PACKARD MOTOR CAR COMPANY
DETROIT · MICHIGAN

TO PACKARD DISTRIBUTERS

Subject, Motor Crankshaft Rear Bearing Oil Leak.

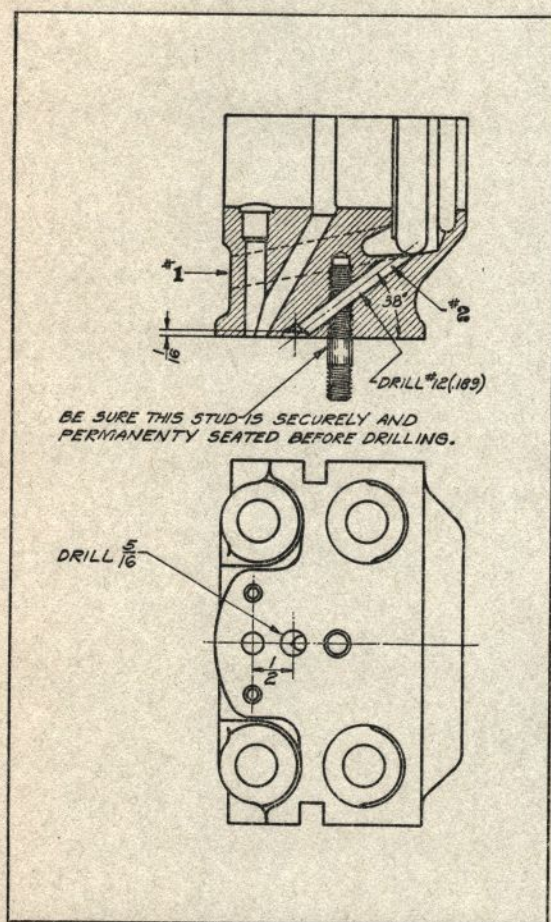
The illustration shows how it is possible to provide more drainage by drilling two additional drain holes. No. 1 shows the original drain hole in the cap, and a similar hole the same size ($\frac{3}{8}$ ") should be drilled in the same relative position on the other side of the web.

The other additional drain is shown by No. 2 and is a No. 12 hole drilled at an angle of 38°. The location and angle of this hole are very important—

First—Because if the upper end of the hole does not meet the bottom of the oil groove it will be of little value.

Second—Because the lower end of the hole must be in line with the center line of the cap and $\frac{1}{2}$ " from the center of the oil hole or the oil will not drain into the crankcase. (Study the illustration, which clearly shows the location of the hole).

All three drain holes should meet the oil groove at the lowest point. If any of the drain holes do not connect with the oil groove in this way the cap should be chipped out, so that it would be impossible for oil to stand in the groove.

It is not necessary to install the drain tube as mentioned in Technical Letter No. 1747 if the cap is provided with the three drain holes described above.
